Subject: Letter of Clarification No. 3 to Invitation to Bid No. S50-C23856 Parking Lot Renovation at 4400 San Jacinto for the General Services Department

**S50-C23856 Parking Lot Renovation at 4400 San Jacinto
for the General Services Department**

Attachment: New Drawing, REVISION 2: EXISTING GRATE INLET

EXISTING GRATE INLET

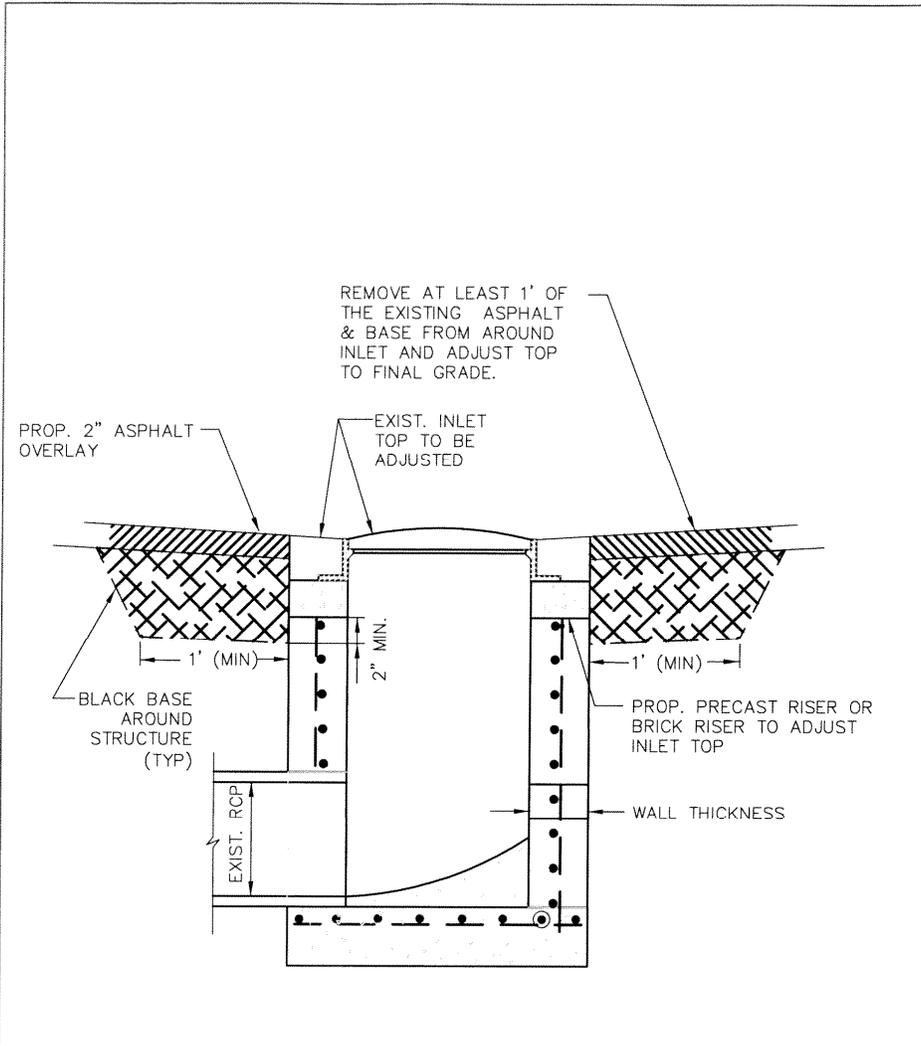
- 1.) See the attached additional drawing titled: REVISION 2: EXISTING GRATE INLET
- 2.) The following questions are as follows:

Question #2 We have specifications that are calling out that the Manholes and Inlets may need to be raised up to match the new 2" Asphalt Overlay, Can you please confirm that this is what you want for us to do at each structure?

Question #5 Instead of raising the drainage Inlet could we excavate around the perimeter and make a smooth transition into the structure?

Answer: There is one existing inlet that is located in the parking lot that needs to be adjusted approximately 3" (currently the grate is approximately 1" below the existing asphalt surface). The existing top with the frame and grate will need to be removed and a precast riser section or brick riser will need to be added and the existing top can be reinstalled if it is not damaged when removed. If the Top is damaged during the removal then it is to be replaced with a new top with a frame and grate. There does not appear any manhole covers in the pavement. If one is found during the construction then it should be adjusted to the final grade of the asphalt by adjustment rings.

Answer: The City has requested that the Inlet be raised to match the top of pavement.
